Model: Model AT-C1 ARDF (DF3000)	Date: 28-Jun-06	No.: RB789001a
----------------------------------	-----------------	----------------

Subject: Firmware Release History (ARDF)		Prepared by: M. Kumagai	
From: 2nd Tech Support Sec. Service Support Dept.			
Classification:	<input type="checkbox"/> Troubleshooting	<input type="checkbox"/> Part information	<input type="checkbox"/> Action required
	<input type="checkbox"/> Mechanical	<input type="checkbox"/> Electrical	<input type="checkbox"/> Service manual revision
	<input type="checkbox"/> Paper path	<input type="checkbox"/> Transmit/receive	<input type="checkbox"/> Retrofit information
	<input type="checkbox"/> Product Safety	<input type="checkbox"/> Other (      )

Model: DF3000		Date: 15-Sep-09	No.: RB789002
Subject: Parts Information		Prepared by: M. Kumagai	
From: 2nd Tech Support Sec. Service Support Dept.			
Classification:	<input type="checkbox"/> Troubleshooting <input checked="" type="checkbox"/> Part information <input type="checkbox"/> Action required <input type="checkbox"/> Mechanical <input type="checkbox"/> Electrical <input type="checkbox"/> Service manual revision <input type="checkbox"/> Paper path <input type="chec

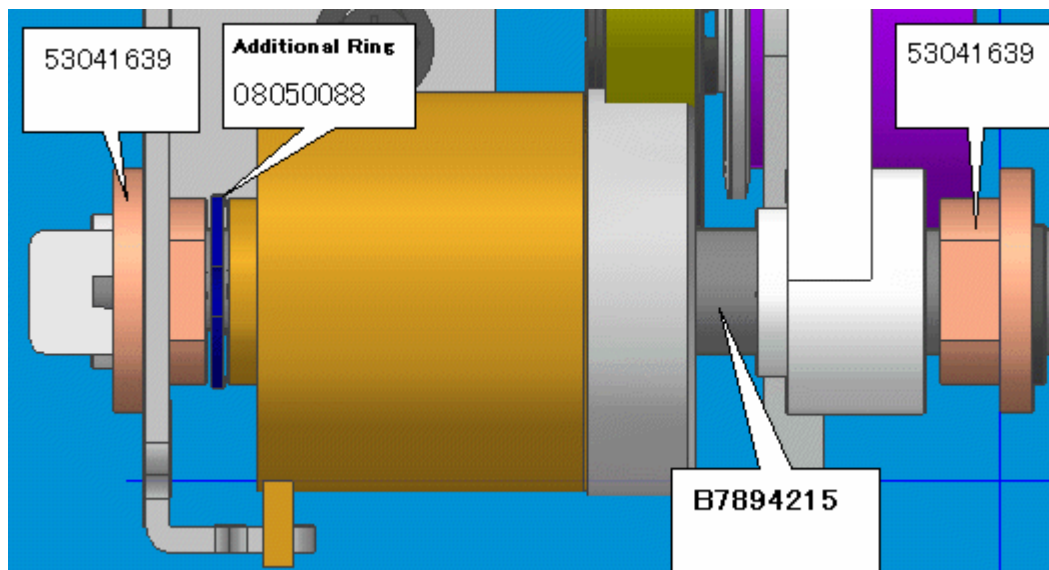
Version	Symptom Corrected
<b>2.35:06</b>	<b><i>Symptom corrected: The tail end of the image is cut off if the original is scanned in duplex mode or using Original Feed Type/Stamp.</i></b>
2.34.06	Symptom corrected: SP6016-1 (Original size detection priority) does not work correctly.
2.33.06	Symptom corrected: The machine stalls if it mis-detects the size of the original during a job set for "Original Feed Type/Stamp" and "Mixed Sizes".
2.32.06	1st mass production

7.Frame Section (D366)

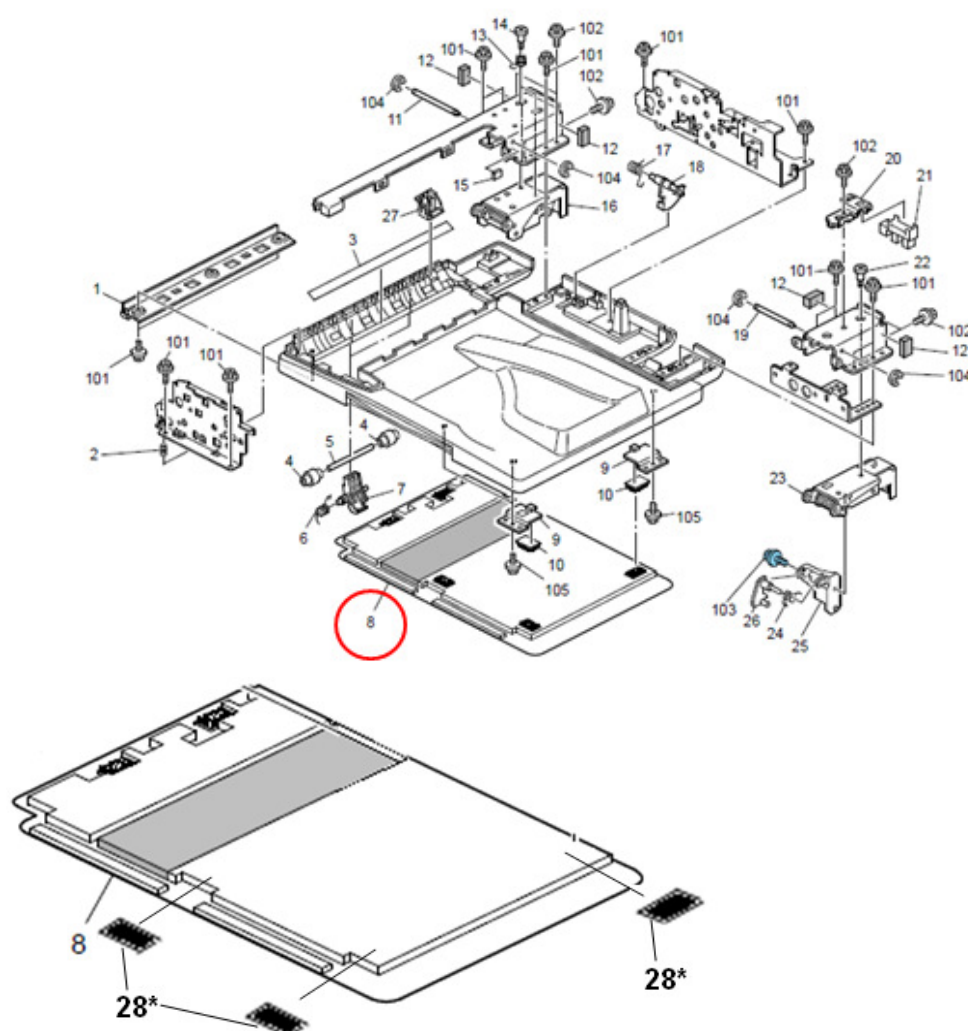
**Change/Reason:** The following part in the parts catalog was incorrect.

New part number	Description	Q'ty	Int	Page	Index	Note
B3514322	TAPE - PLATEN SHEET	3		15	28*

**Note:** Index 8 (PRESSURE PLATE ASS'Y) does not include index 28\* (TAPE - PLATEN SHEET).

**\*New Index**
